To: Prospective Bidders  
From: Wold Architects and Engineers  
Date: July 30, 2014  
Comm. No: 133024

Subject: **Addendum No. 3** for Bidding Documents for the: **Courthouse Renovations Phase I & II**

This addendum forms a part of the Contract Documents dated July 3, 2014. Acknowledge receipt of this Addendum on the space provided on the Bid Form. Failure to do so may result in disqualification of Bid.

14 SECTION @ STAIRS  
3/8" = 1'-0"

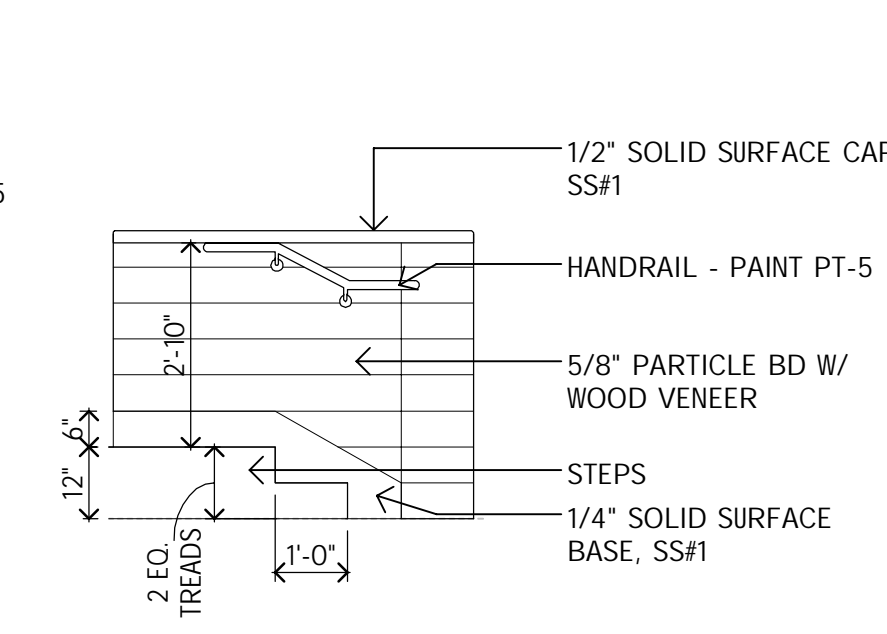
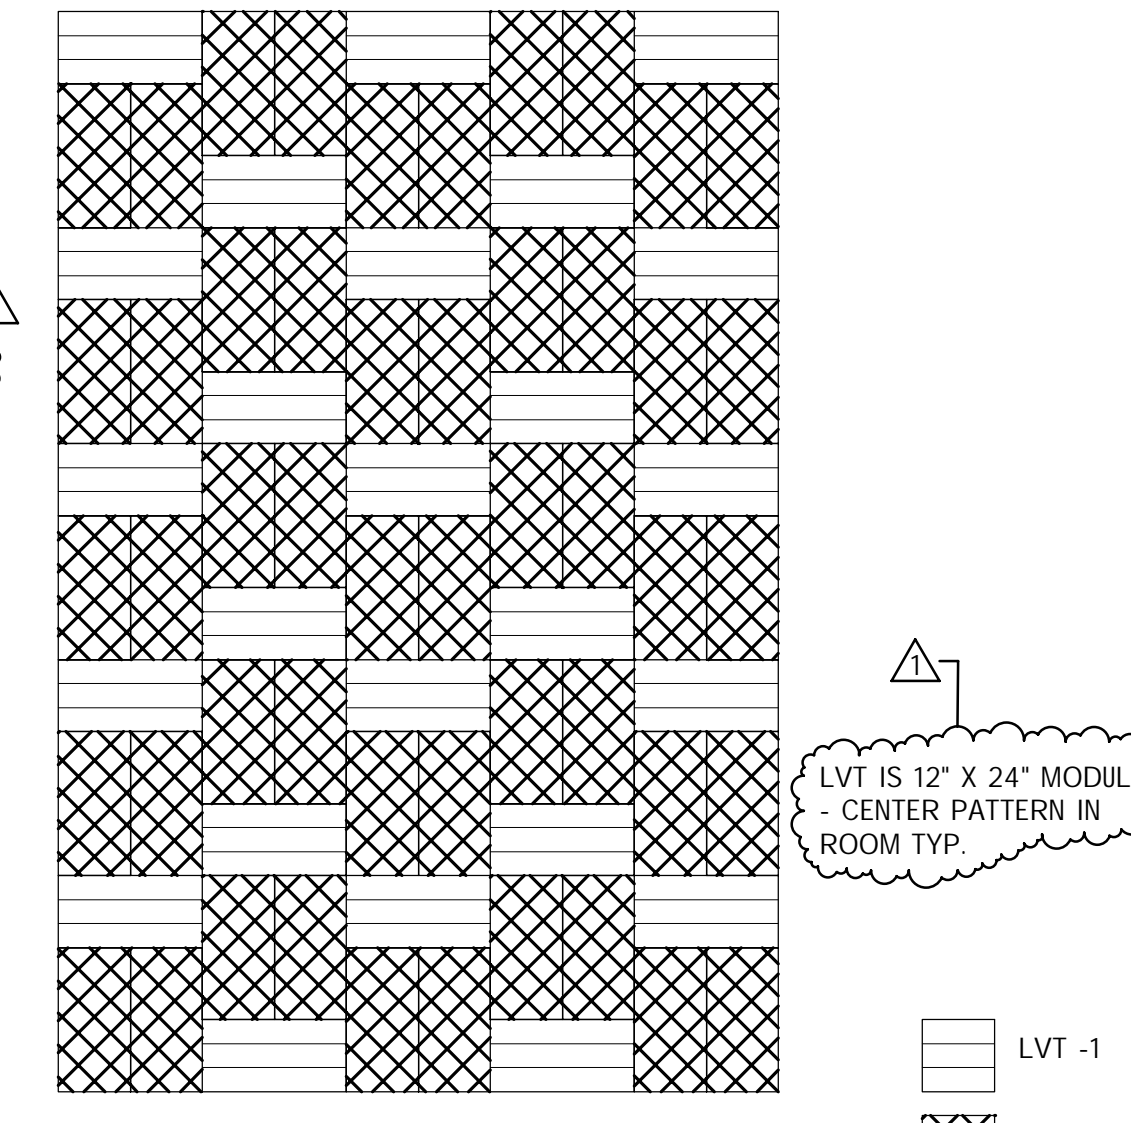
A. Refer to attached Sheet A3.01 for the following revisions;

1. Addition of detail and elevation callouts at casework rail at Enlarged Magistrate Plan 8.
2. Clarification to notes at Ramp Section 13.
3. Clarification to notes at Elevations 9, 11, and 12.
4. Clarification to Floor Pattern 16.
5. Clarifications made to Enlarged Toilet Plan 7.
6. Revision of Tile Pattern Detail 6 title.

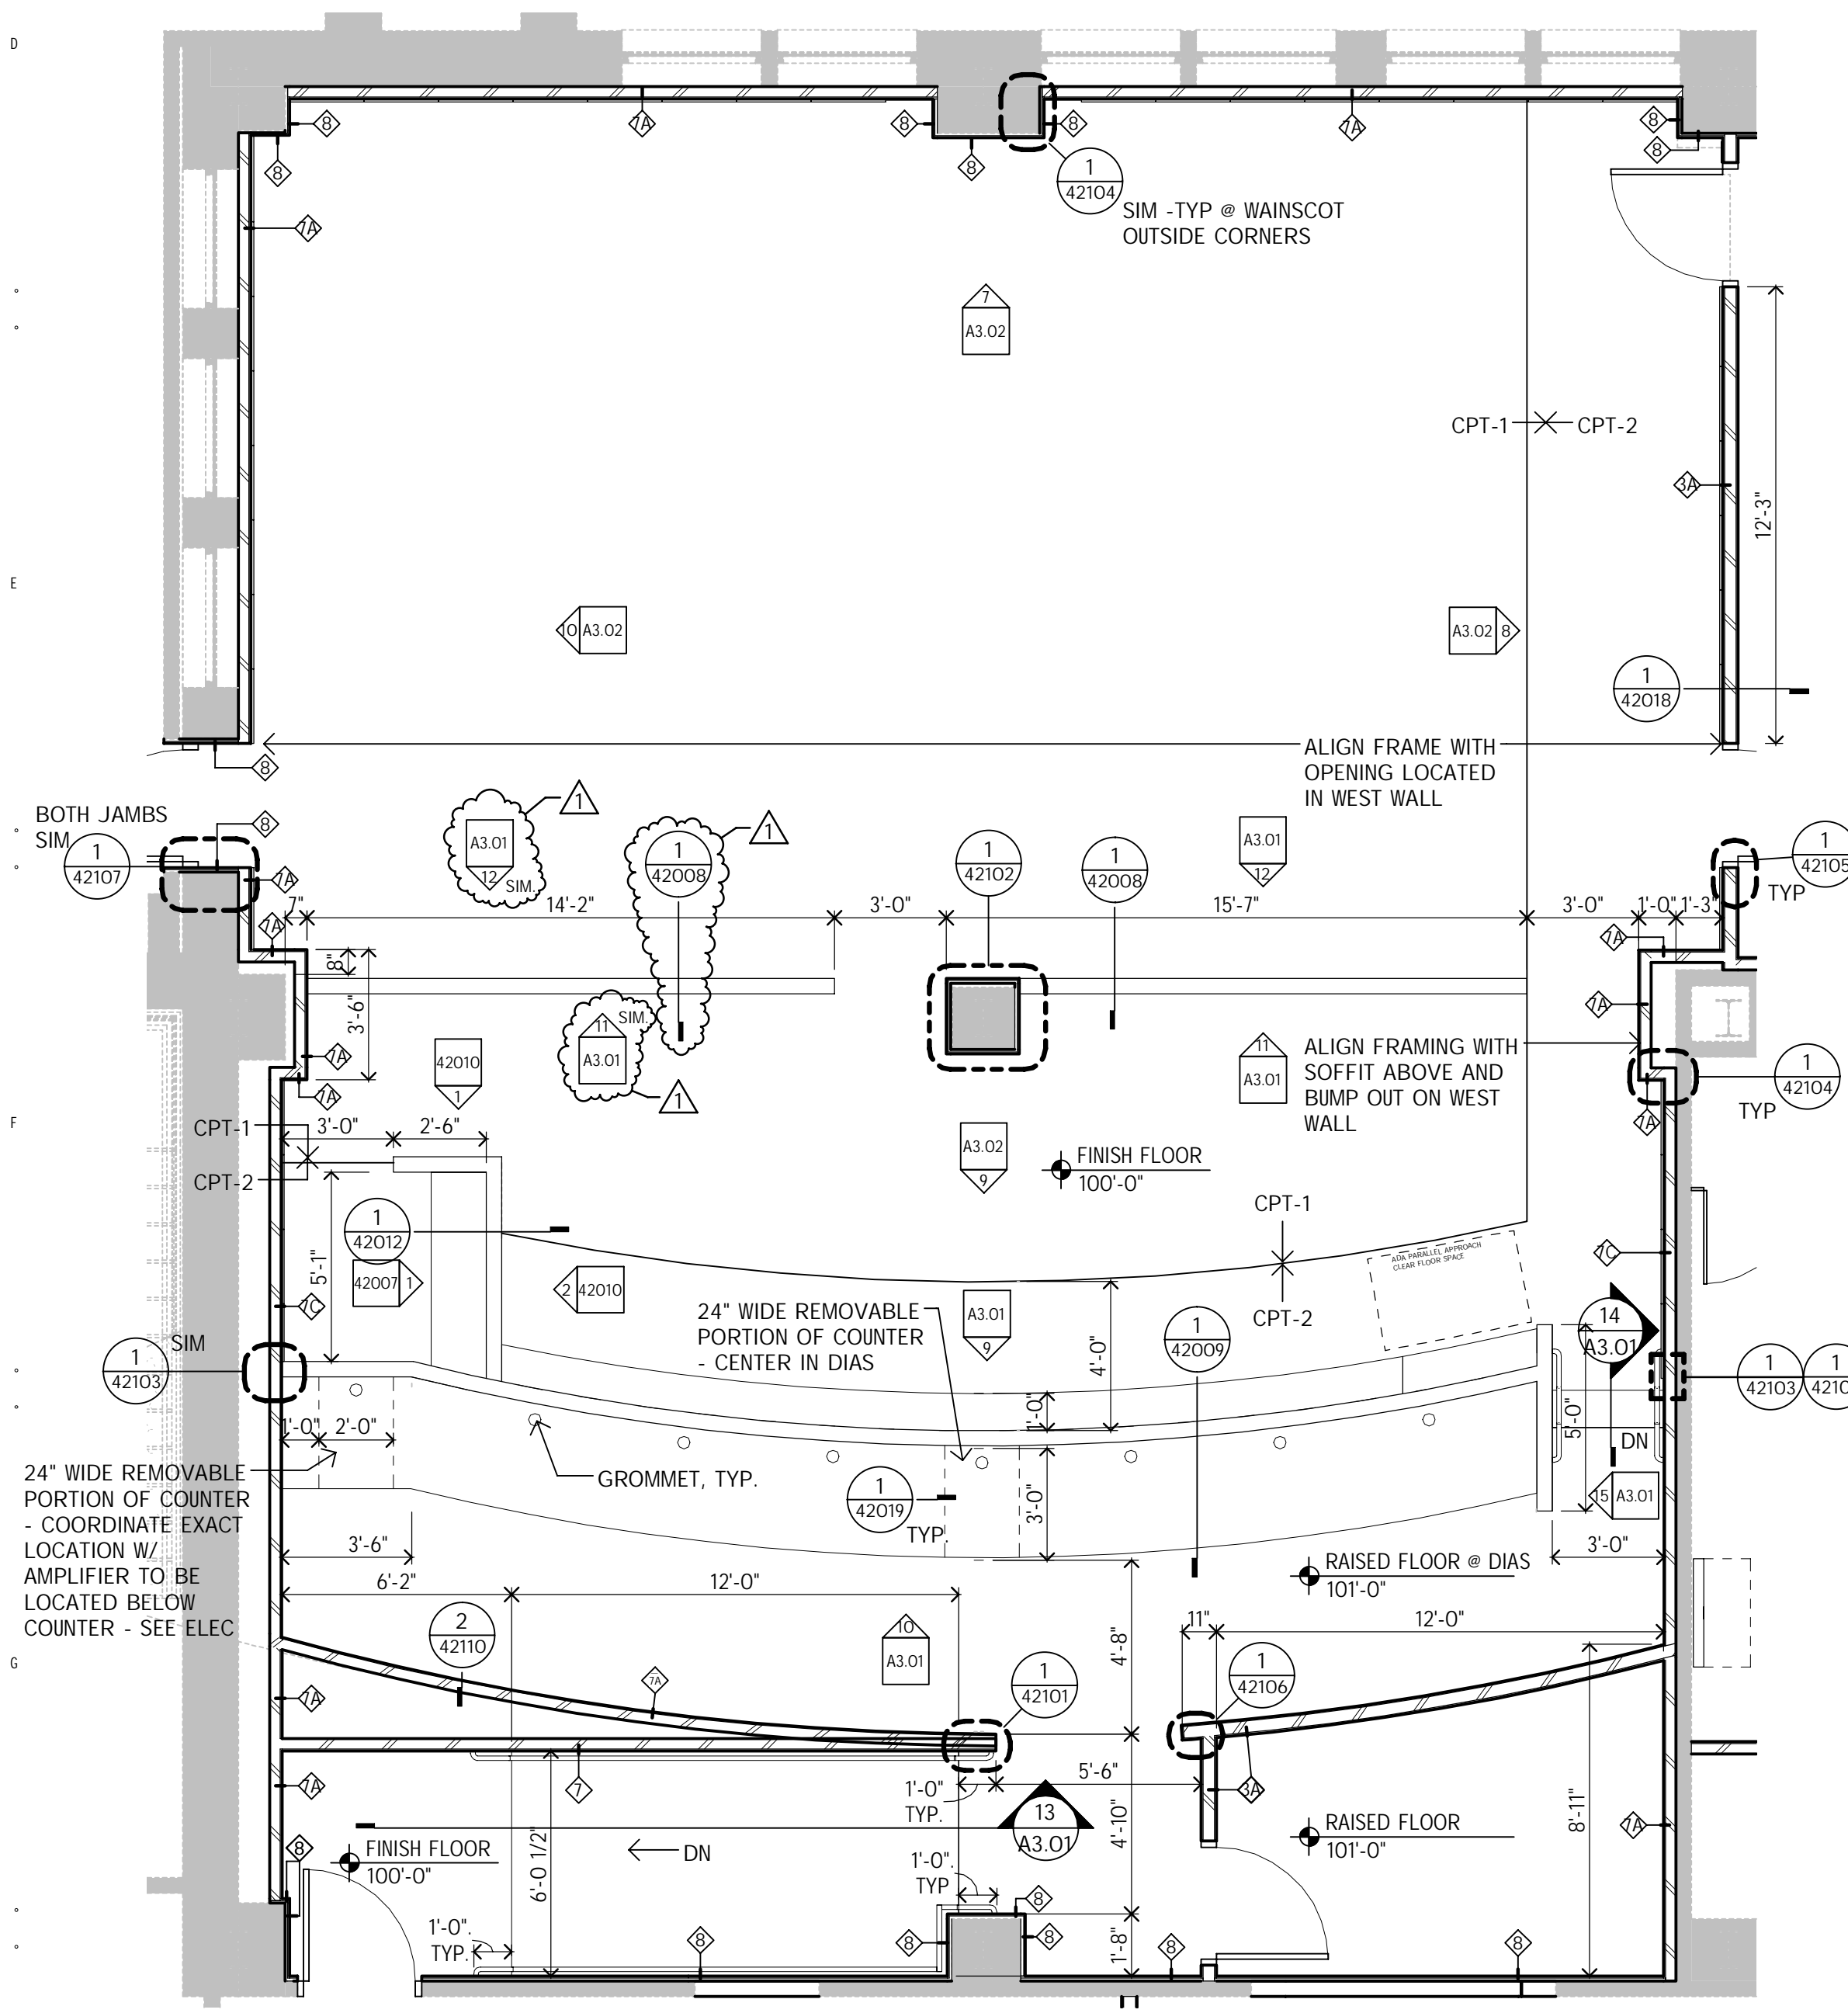
1. Additional of fire extinguisher locations noted as FE on plans.
2. Revision of "granite" panels, base and cap to "marble" panels, base and cap at various locations.
3. Removal of Keynote #15 from the floor plan and Floor Plan Keynotes.
4. Addition of dimensions for clarification.
5. Clarifications to the Floor Plan Keynotes.
6. Clarifications to Room Finish Schedule.
7. Clarifications to Room Finish Schedule Remarks.
8. Clarifications to Door/Opening Schedule and Door Schedule Remarks.

### 6. SHEET AD1.11 – MAIN LEVEL DEMOLITION PLAN

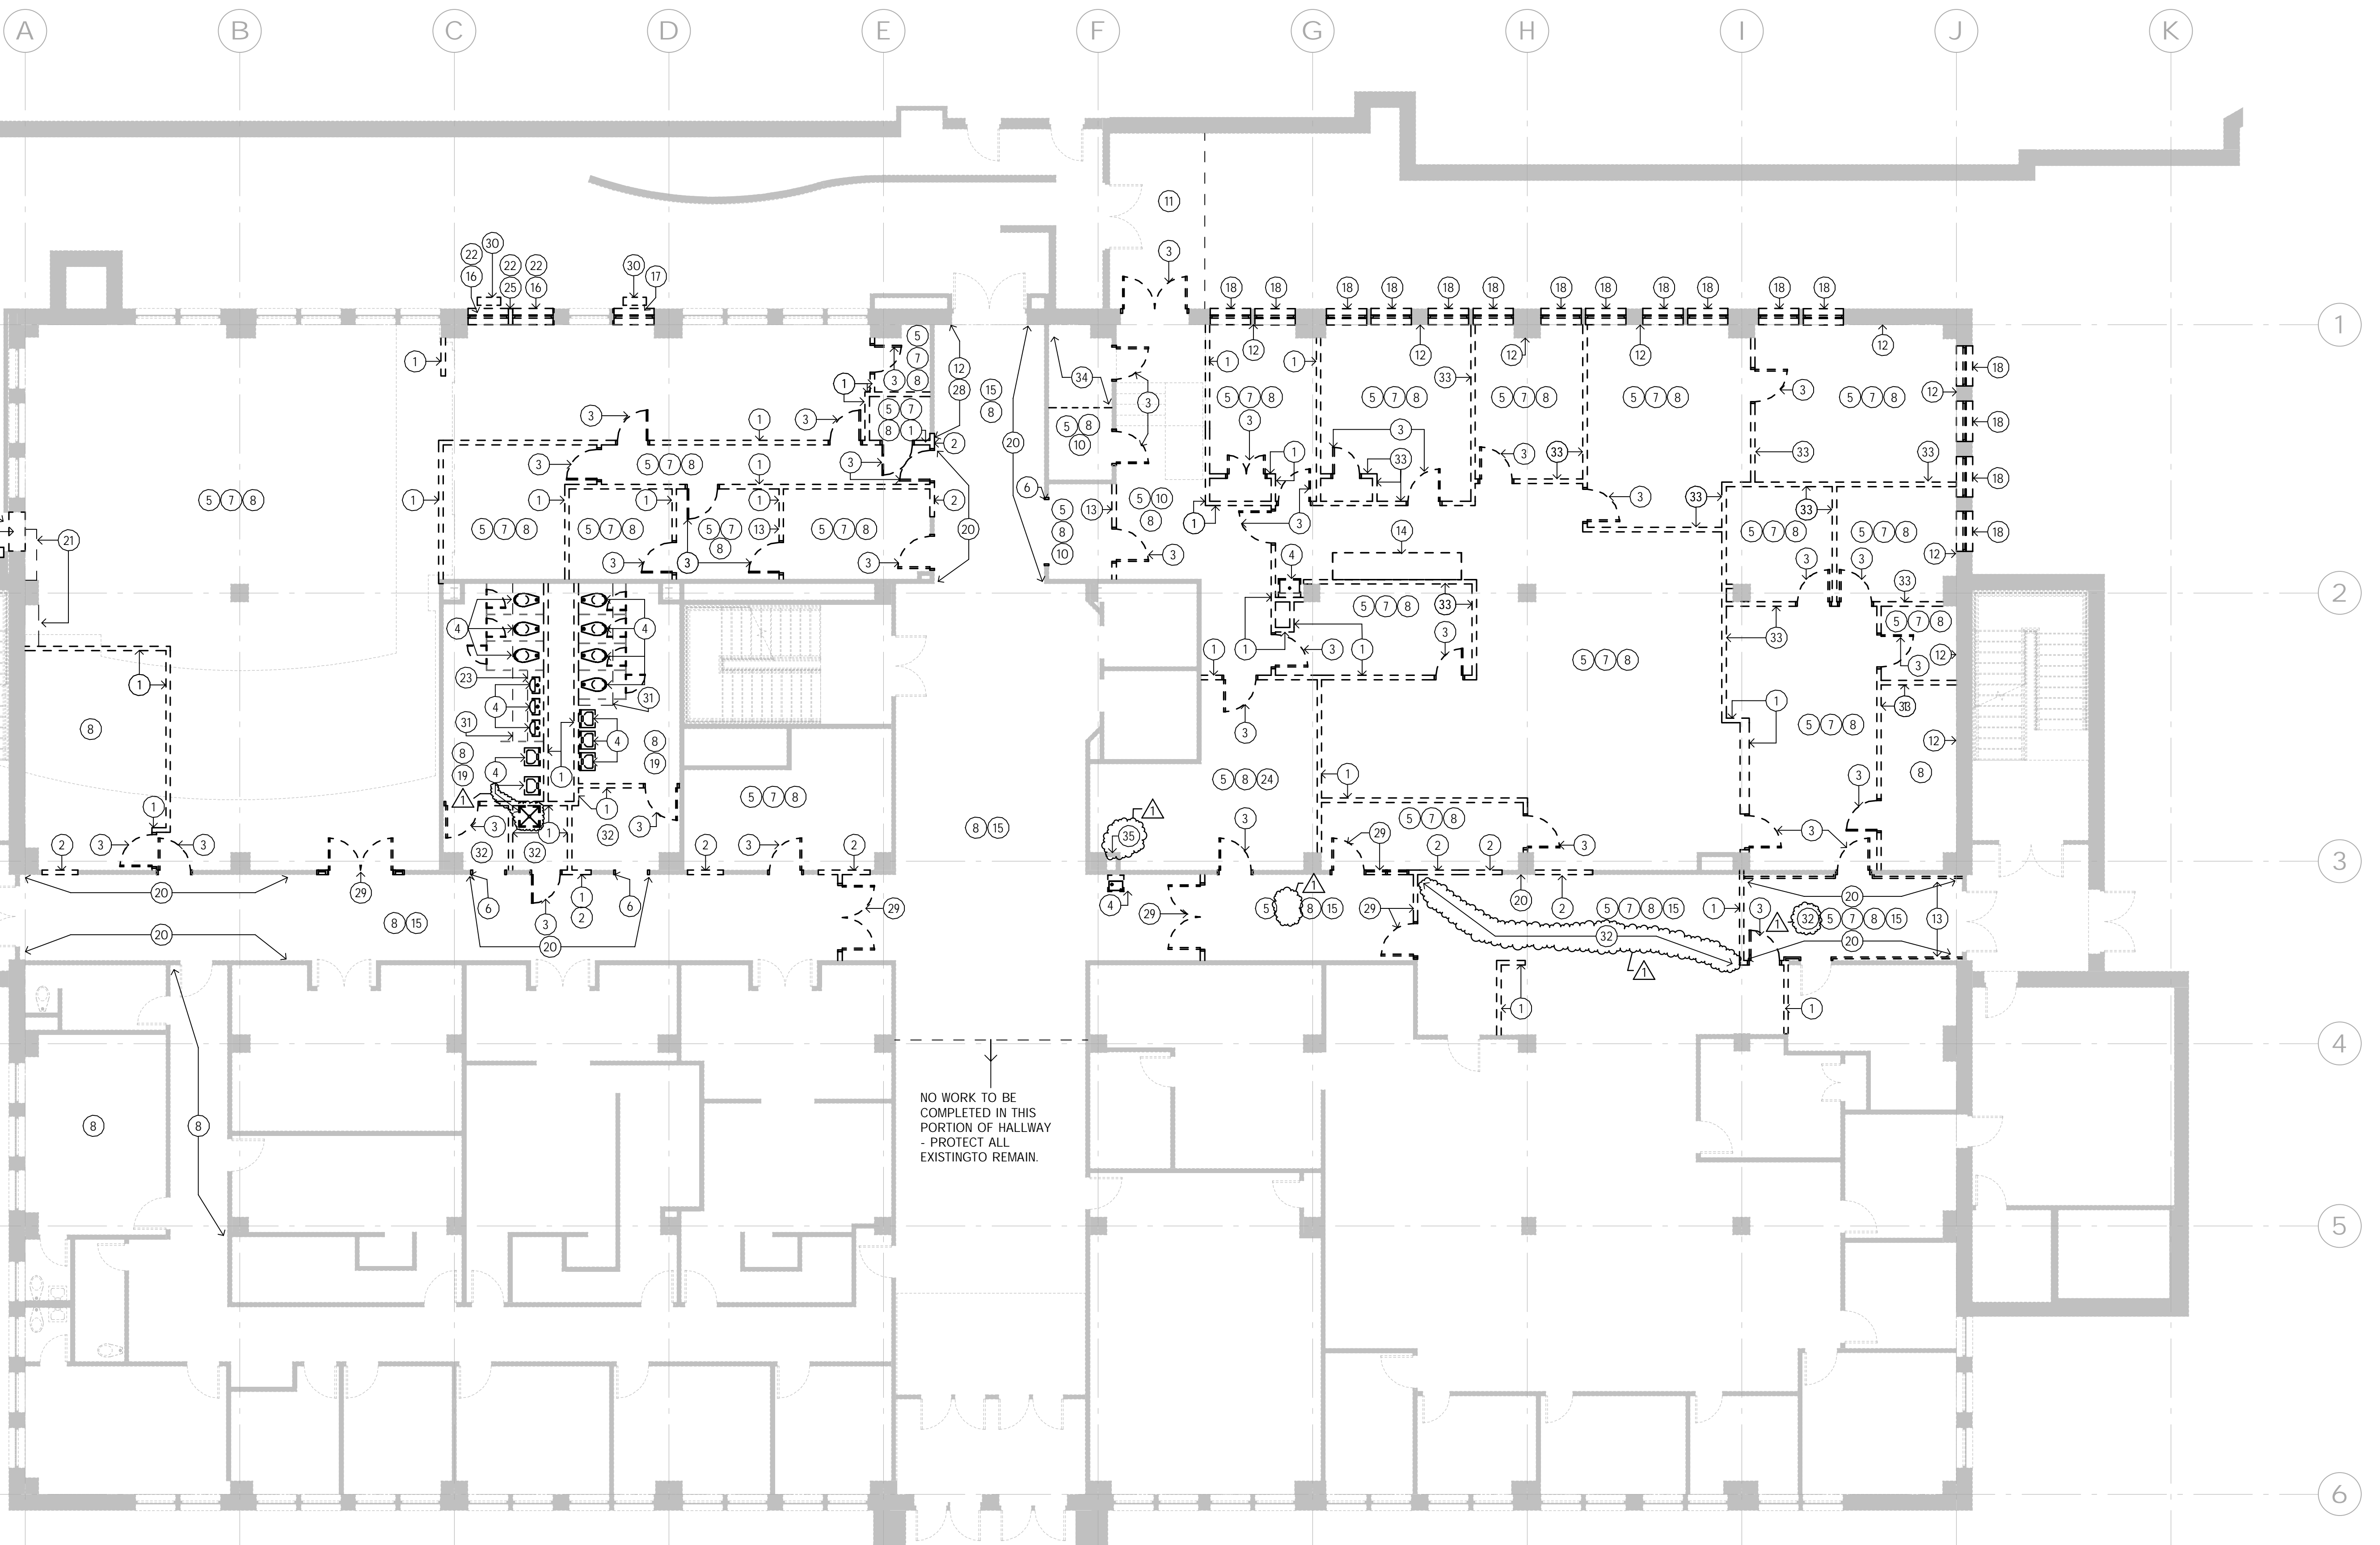
A. Refer to attached Sheet AD1.11 for revisions to Demolition Plan Key Notes and additional Key Notes added to Phase 1 area of plan.
